# **Descriptive Report to Accompany Hydrographic Survey H11492**

Project OPR-P132-RA-05  
Boulder Bay  
Eastern Prince William Sound, Alaska  
Scale 1:10,000  
September-October 2005  
**NOAA Ship RAINIER (s221)**  
Chief of Party: Commander Guy T. Noll, NOAA

## Revisions Compiled During Office Processing and Certification

Figure 1. H11492 Survey limits and junctions overlaid on chart 16708.

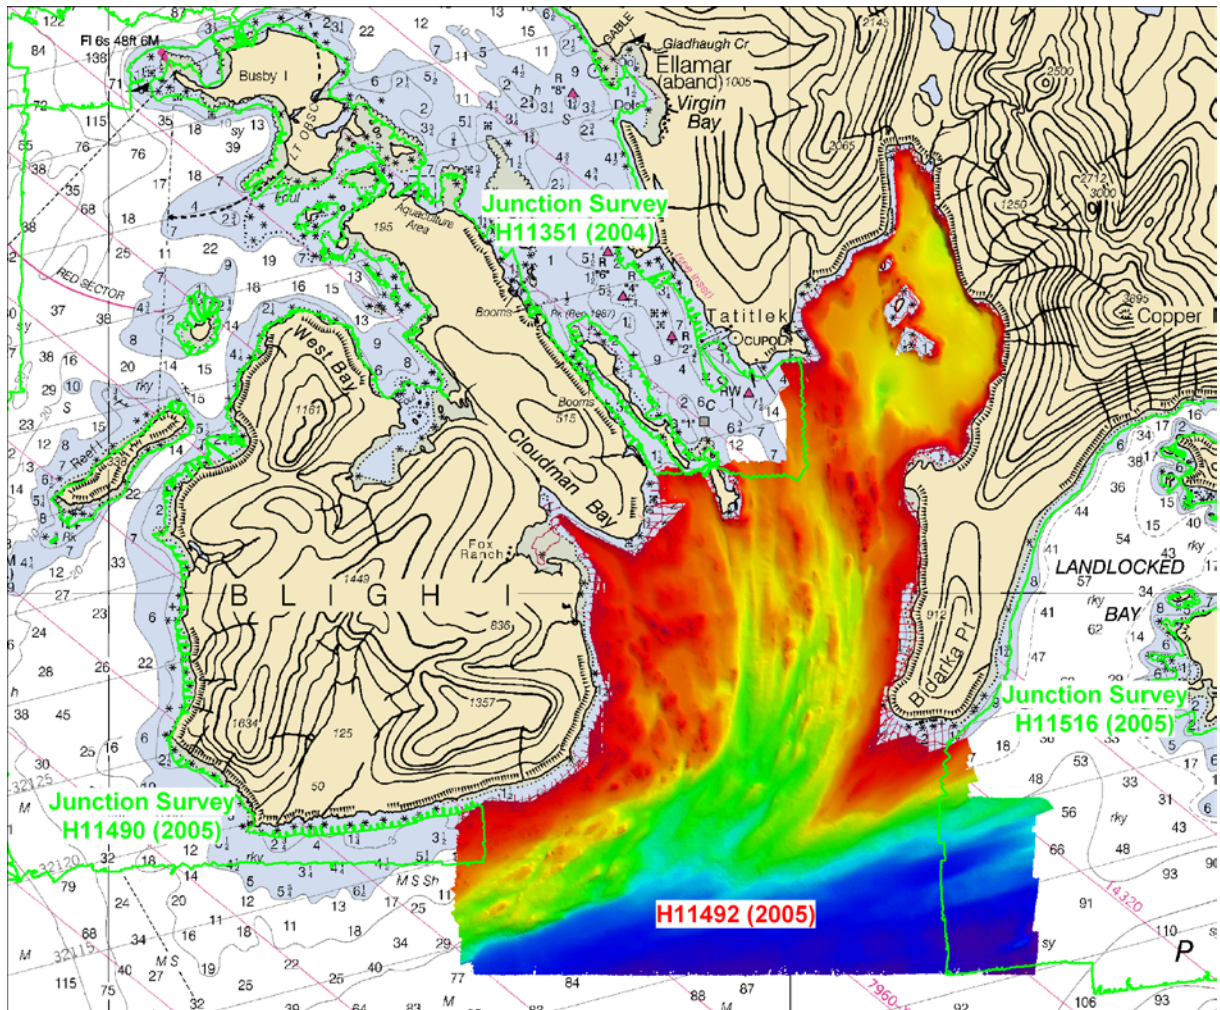
The following contemporary surveys junctions with H11492 (See Figure 1)<sup>2</sup>:

Surveys H11490 and H11516 were accomplished in parallel with H11492. Bathymetry was compared in CARIS HIPS subset mode, with excellent agreement observed. H11490 differed

from H11492 by half a meter or less in the common area. There were no discernable differences between H11492 and H11516.<sup>3</sup>

Survey H11351 was compared to H11492 by viewing smooth sheet soundings in Mapinfo. This comparison indicated differences of generally less than one meter in the common area.<sup>4</sup>

<sup>2</sup> In addition to the listed junction surveys, there are two more adjoining surveys that have been compiled to HCells.

<u>Register#</u>	<u>Scale</u>	<u>Date</u>	<u>Junction Side</u>
H11742	10,000	10/10/2007	South
H11743	10,000	10/03/2008	Southwest

<sup>3</sup> Concur.

<sup>4</sup> Concur.

Figure 2. 0.5m BASE Surface, showing positions of significant holidays.

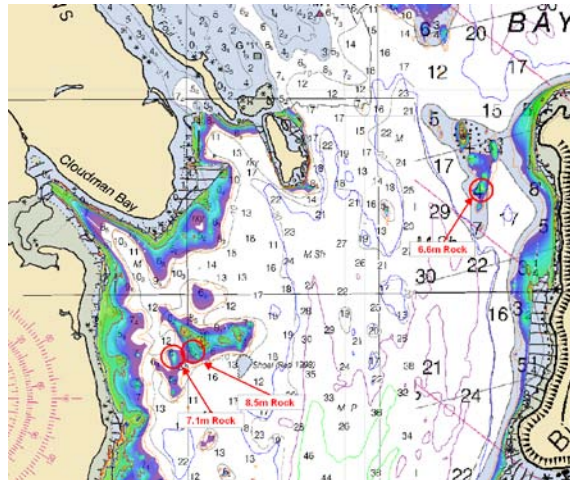
There are three cases of potentially significant holidays over offshore rocky outcroppings. In each case, a small (~5-10m wide) gap in MBES coverage occurred at the top of the outcrop. These holidays were not apparent until the data were fully processed and viewed at the appropriate final BASE surface resolution (0.5m). By this time, RAINIER had left the survey grounds due to the weather conditions discussed above, and it was not possible to obtain additional coverage. These holidays are detailed in Table 2 and illustrated in Figure 2.

In all three cases, the bathymetry obtained is sufficiently shoal to indicate the safe navigation route around these features on the nautical chart. The hydrographer recommends charting these soundings without qualification.<sup>6</sup> The hydrographer further recommends that all three features be added to the AWOIS database for further investigation when field units return to Port Fidalgo to complete the remaining surveys in this area. Diving for confirmation of least depth is recommended.<sup>7</sup>

<sup>7</sup> Concur with clarification. Full multibeam coverage is sufficient for least depth determination.

Figure 3. Areas of incomplete coverage. Solid ellipses are significant areas of VBES coverage at line spacing greater than 25m. Dashed ellipses are significant areas where 100% MBES coverage did not extend inshore to the 8m curve.

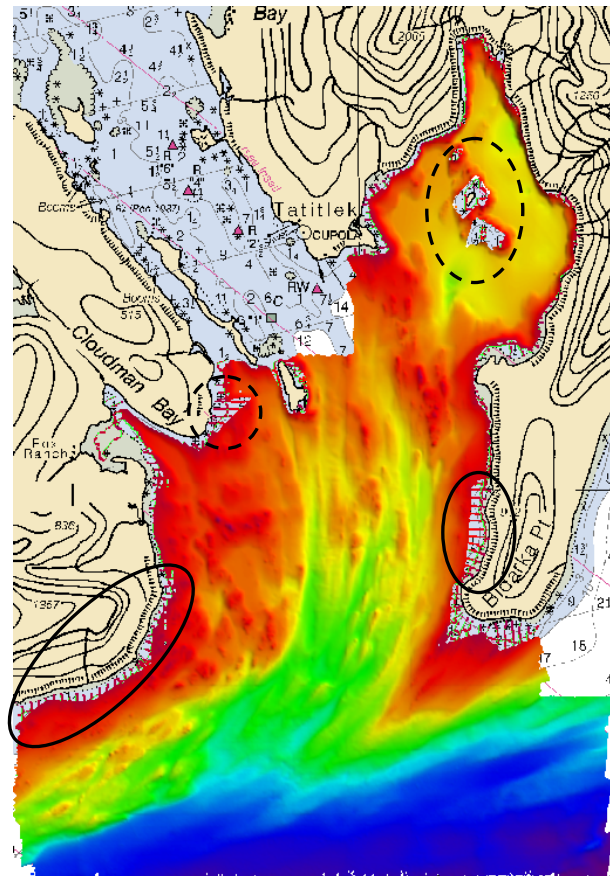
Figure 3. shows several areas where MBES coverage was not completed to the 8m contour and inshore VBES coverage was accomplished only to 100m line spacing rather than 25m line spacing, as required by the Letter Instructions. The hydrographer recommends that unaddressed charted features in these areas be retained.<sup>8</sup>

<sup>8</sup> Concur.
